Reference Air Quality Analysis for Prevention of Significant Deterioration

Subject Response to DEP Comments

Air Quality Modeling Report Ethane Chilling Expansion Project

Marcus Hook, Delaware County, Pennsylvania
February 2023

Appendix B
Source Point and Downwash
Area Modeling
Marcus Hook
Energy Transfer Partners L.P.
Marcus Hook, Pennsylvania

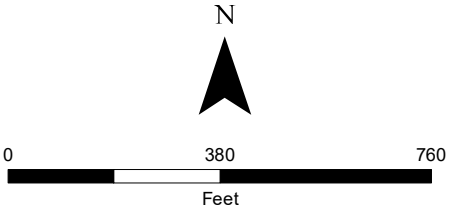
9. **This subsection should include a reference to Attachment B (Facility Layout) which contains the “Source Point and Downwash Area Modeling” imagery.**

10. **The BPIPPRM input file should be updated to reflect any changes to the facility layout associated with the sources authorized in Plan Approval 23-0119J. For example, the location of downwash structure “BLD_4” (Bldg 854) overlaps with the locations of the 2WSAC1 and 2WSAC2 (Wet Surface Air Cooler) sources. Additionally, two new tanks to be installed under Plan Approval 23-0119J are not included in the BPIPPRM input file and are not depicted in Attachment B. Also, a building to the west of the 1WSAC and 2WSAC sources and southwest of the ME2XCFLP (ME-2x ColdFlare LP) and ME2XCFLP (ME-2x ColdFlare HP) sources was not included in the BPIPPRM input file.**

11. **Downwash structures “TANK_5” (522) and “TANK_6” (390) are both included in the BPIPPRM input file and appear in Attachment B. However, the March 2020 renewal of the Title V Operating Permit 23-00119 notes the removal of both structures. Therefore, the BPIPPRM input file and Attachment B should be updated.**

14. Appendix B (Plot Plan) highlights the locations of the new refrigeration train (Train D) and Boil Off Gas (BOG) system. Do either of these locations contain structures that should be included in the BPIPPRM input file as well as Attachment B?

A reference to Attachment B was added to Section 2.3.

The BPIPPRM input file was updated to include the two planned tanks and the building to the west of the WSACs. BLD_4 was removed from the BPIPPRM input file.

Tank 5 and Tank 6 were removed in the updated BPIPPRM input file.

TANK_5 and TANK_6 were removed, BLD_60 and BLD_61 were added to the BPIPPRM input file and to Attachment B.
